13.0 ACCIDENT ANALYSIS

This chapter of the Northwest Medical Isotopes, LLC (NWMI or the applicant) construction permit safety evaluation report (SER) describes the U.S. Nuclear Regulatory Commission (NRC) staff (the staff) technical review and evaluation of the preliminary accident analysis of the NWMI production facility as presented in Chapter 13.0, "Accident Analysis," of the NWMI preliminary safety analysis report (PSAR), Revision 3, and NWMI's responses to requests for additional information (RAIs).

Figure 13.4.10-1 Scaled Distance-Overpressure Relationship

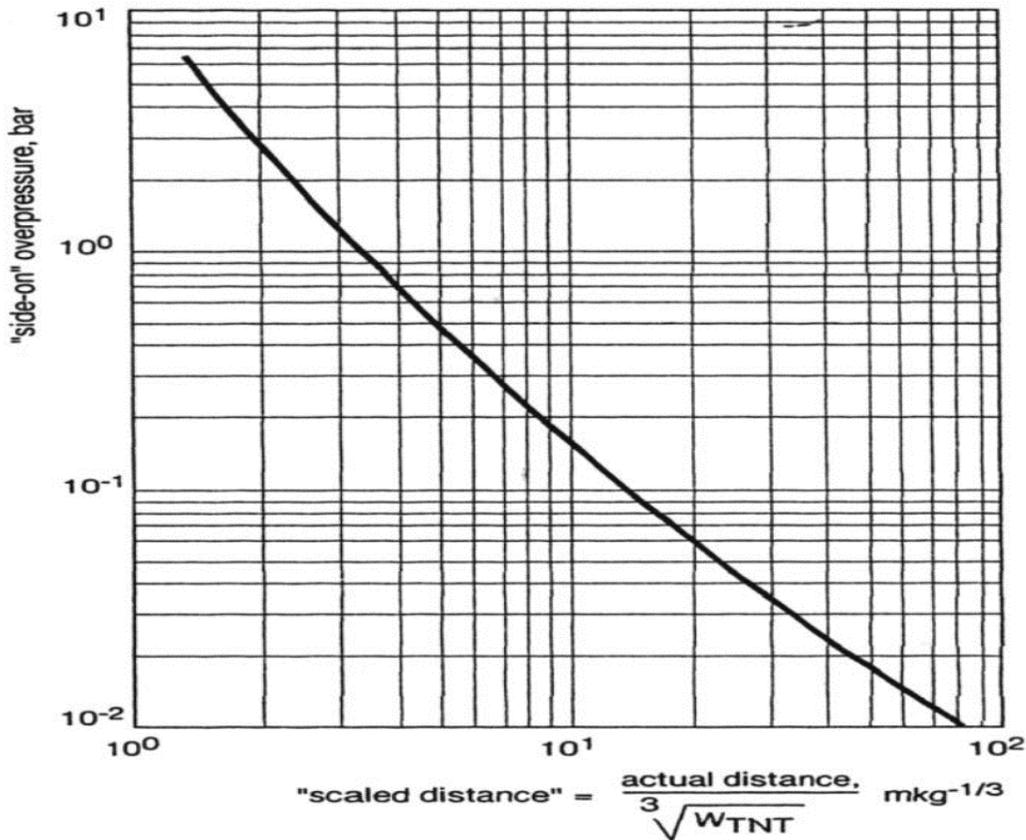
An evaluation of the potential damage from an ion exchange exothermic reaction was made using a correlation that related "scaled distance" for trinitrotoluene (TNT)-equivalent explosion to "side-on" overpressure that the nearest confinement barrier would experience. This correlation between scaled distance and overpressure is commonly found in the literature evaluating the effects of explosions.¹ SER Figure 13.4.10-1, "Scaled Distance-Overpressure Relationship," shows this distance-overpressure relationship. The use of this relationship is generally considered to be conservative because the energetic ion exchange reactions can often proceed at a slower, non-explosive rate resulting in reduced overpressures.
